HISTORIC AND DESIGN REVIEW COMMISSION

October 19, 2022

HDRC CASE NO: 2022-506
ADDRESS: 825 E HARLAN AVE
LEGAL DESCRIPTION: NCB 7729 BLK 9 LOT E 171.7 FT OF 11 THRU 14, EXC SE 6.50FT X 10.15FT
ZONING: MF-33, H
CITY COUNCIL DIST.: 3
DISTRICT: Mission Historic District
APPLICANT: Kevin Sekula/SEKULA KEVIN
OWNER: Kevin Sekula/SEKULA KEVIN
TYPE OF WORK: Installation of doors and windows, driveway modifications
APPLICATION RECEIVED: September 19, 2022
60-DAY REVIEW: Not applicable due to City Council Emergency Orders
CASE MANAGER: Jessica Anderson
REQUEST:

EXISTING WINDOWS & EXT. DOORS

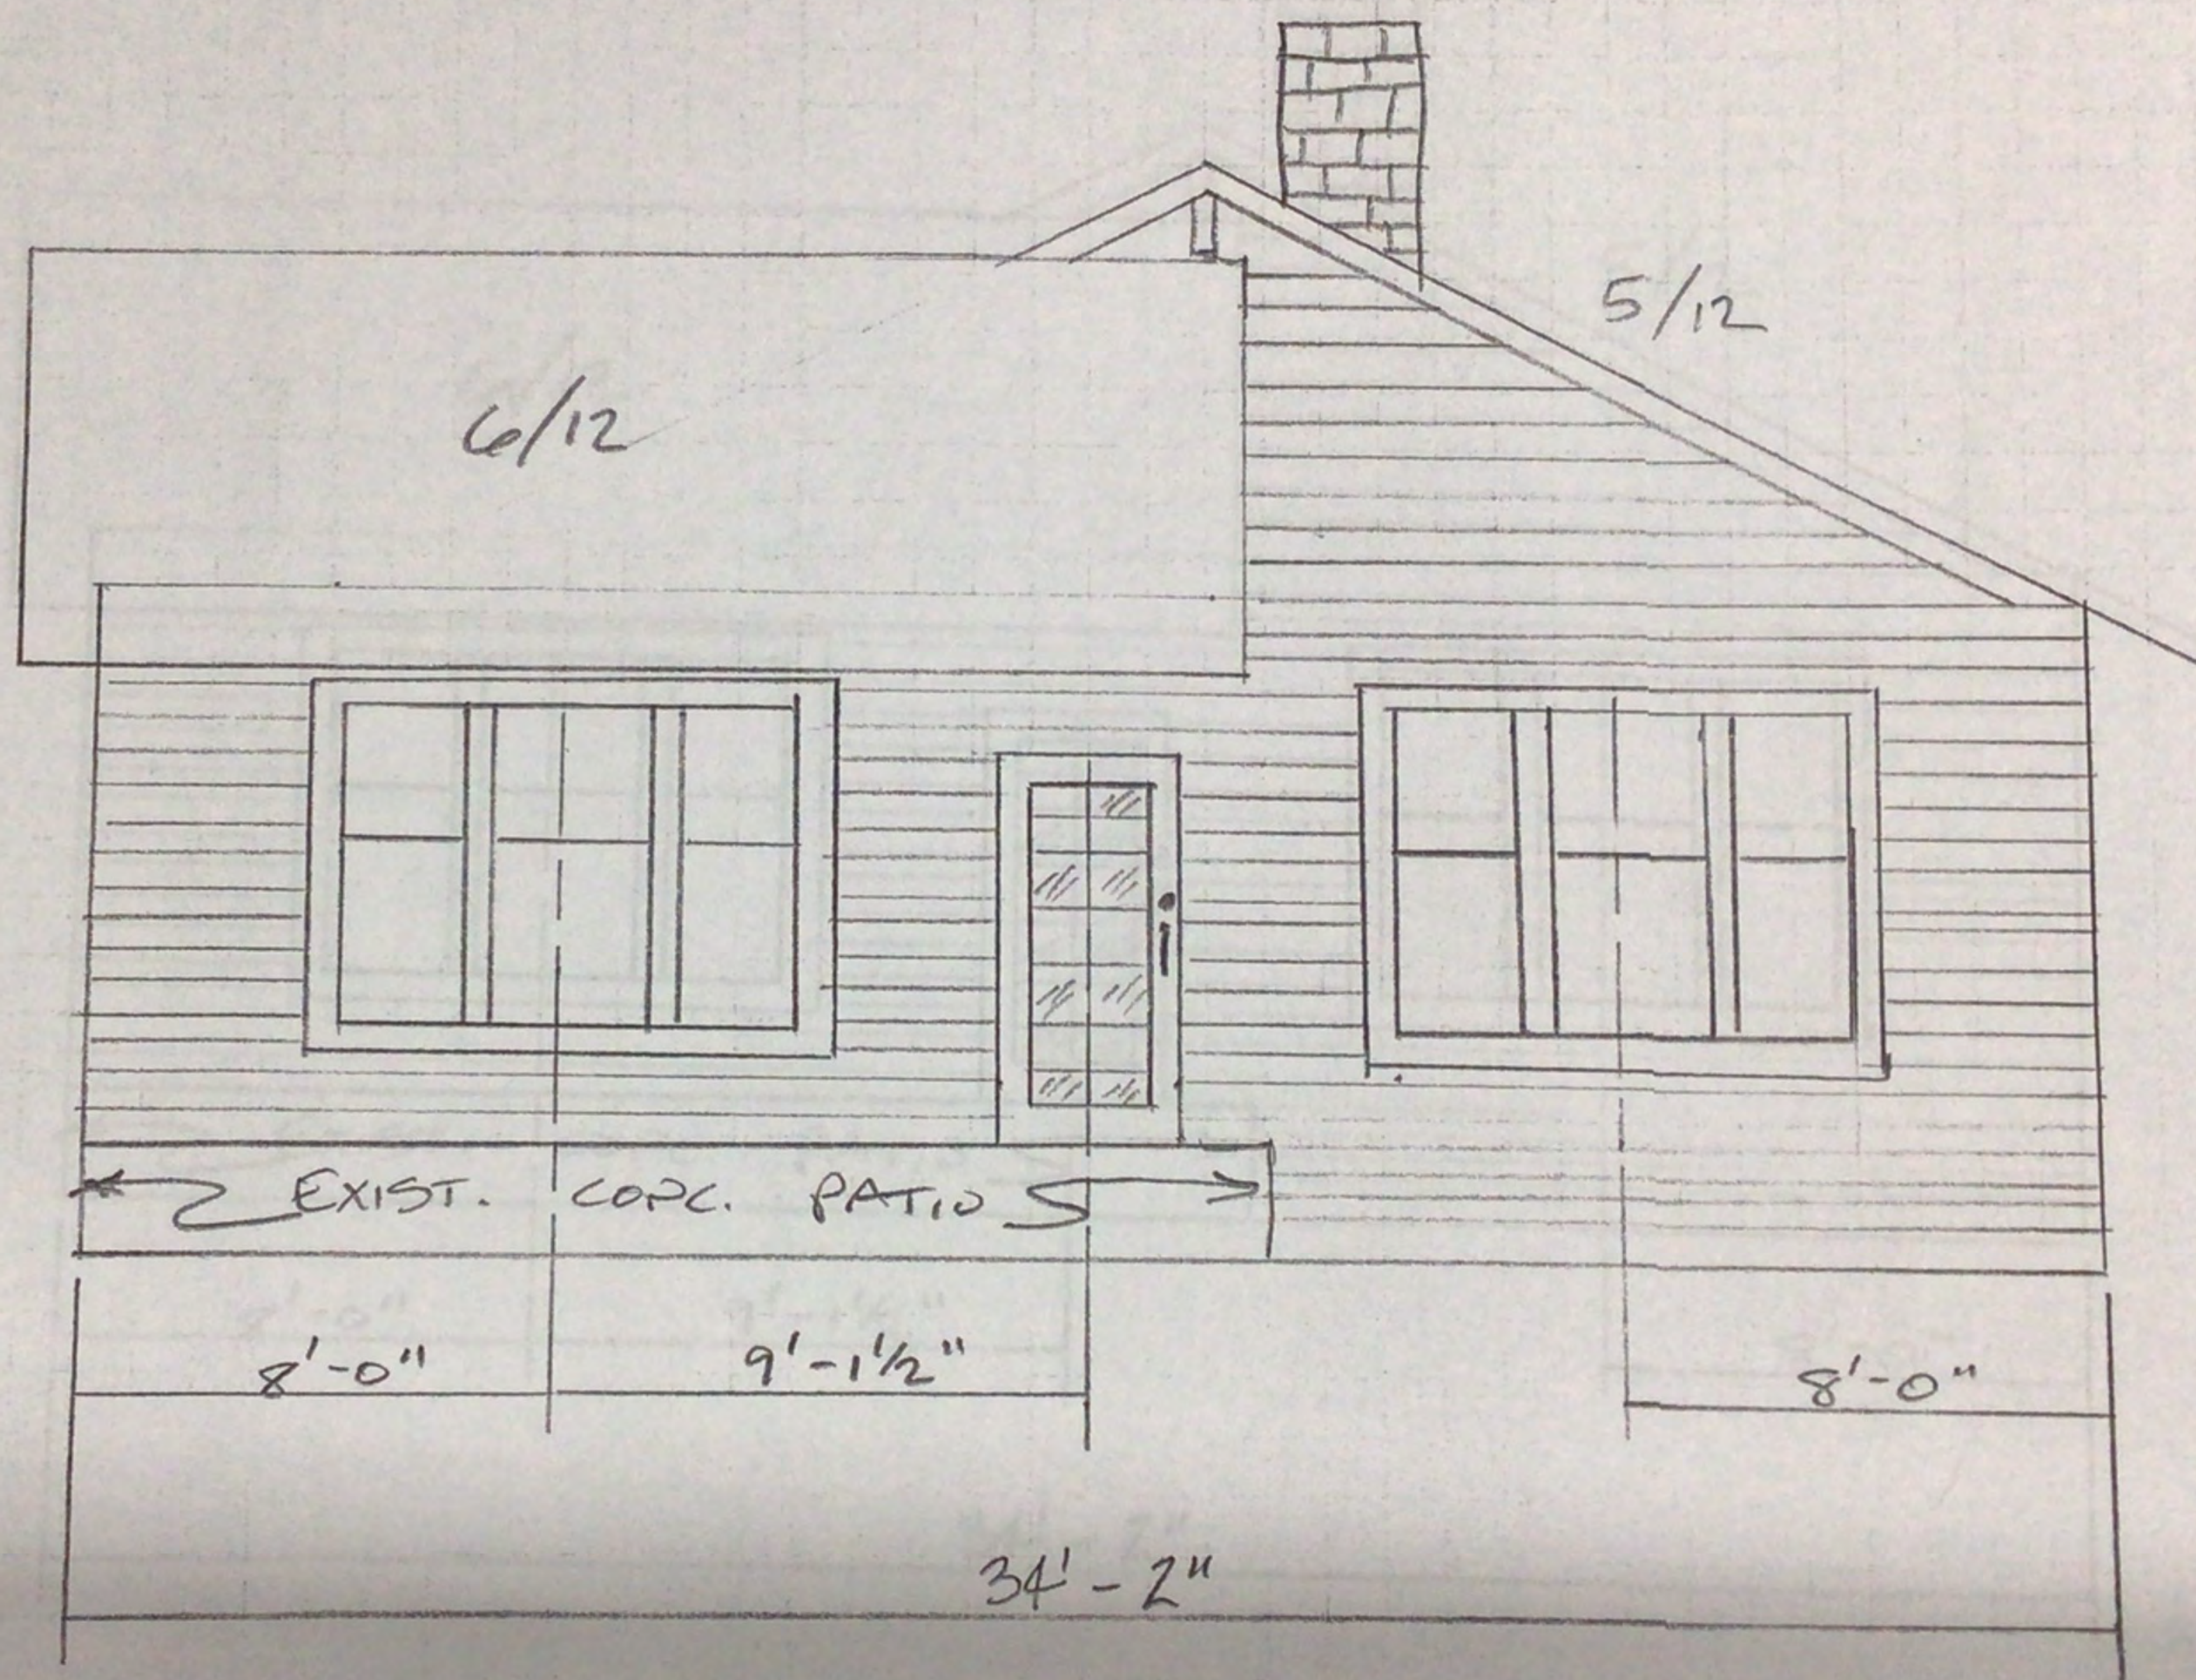
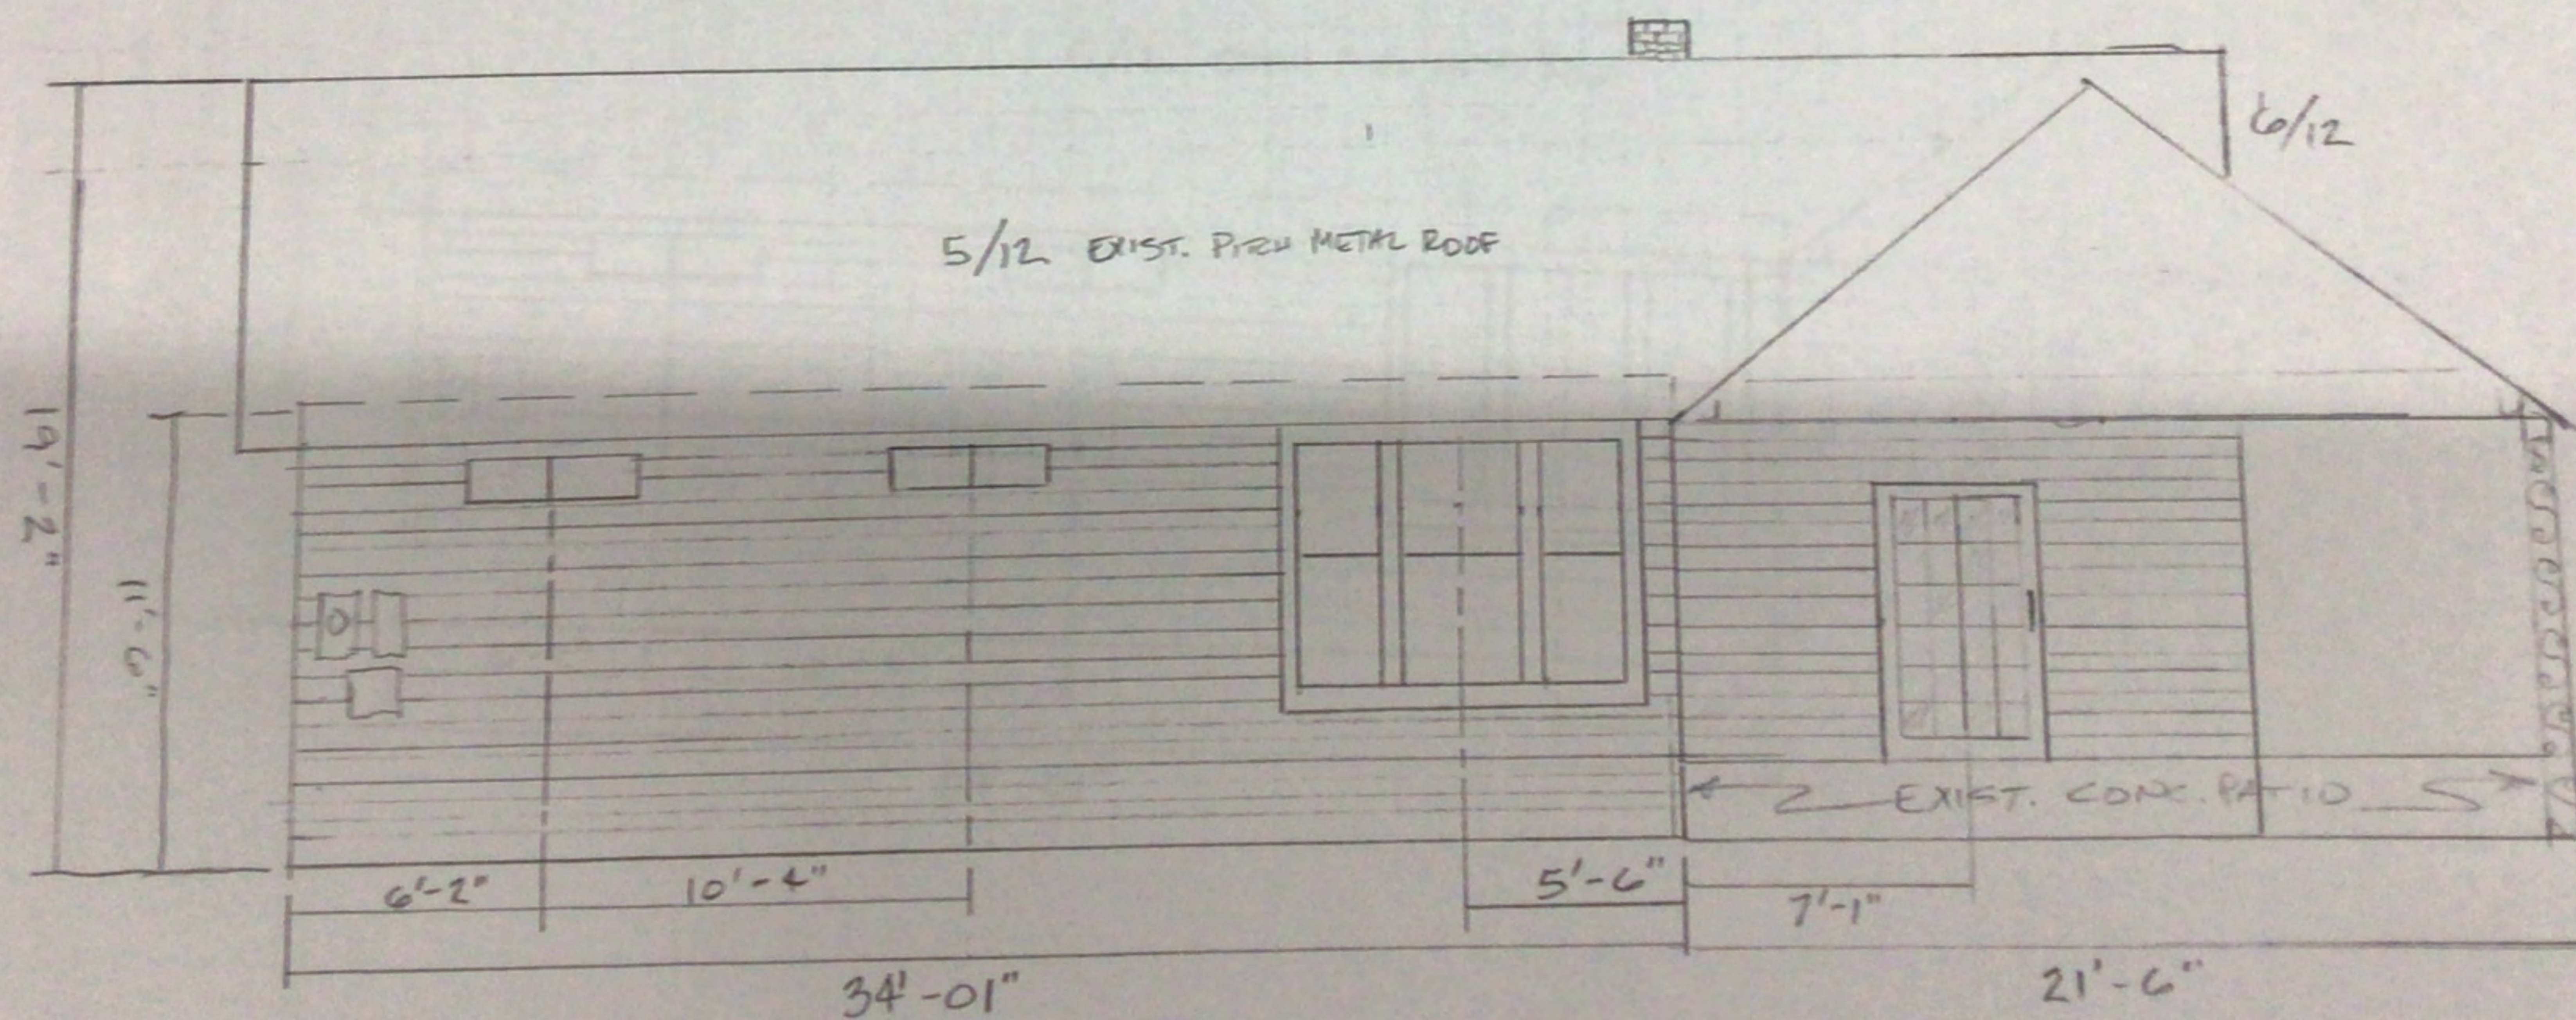
W1 - MOVE & FROM 10'-7" TO 7'-6"

D1 - DELETE

W2 - CHANGE TO EXT. DOOR 3' 6"

W3 - CHANGE & FROM 7'-1" TO 5'-6"

W5, D2 & W6 REMOVE & MATCH W4

D3 - CHANGE TO SINGLE 4' 6"

W7 - NO CHANGE

W8 - CHANGE FROM DBL TO (2) SINGLE 1" TALL X 3" WIDE

W7A - ADD (1) SINGLE 1" TALL X 3" WIDE

W9 - DELETE

Staff does not recommend approval of item 3, changing the fenestration pattern across all elevations, based on finding d.
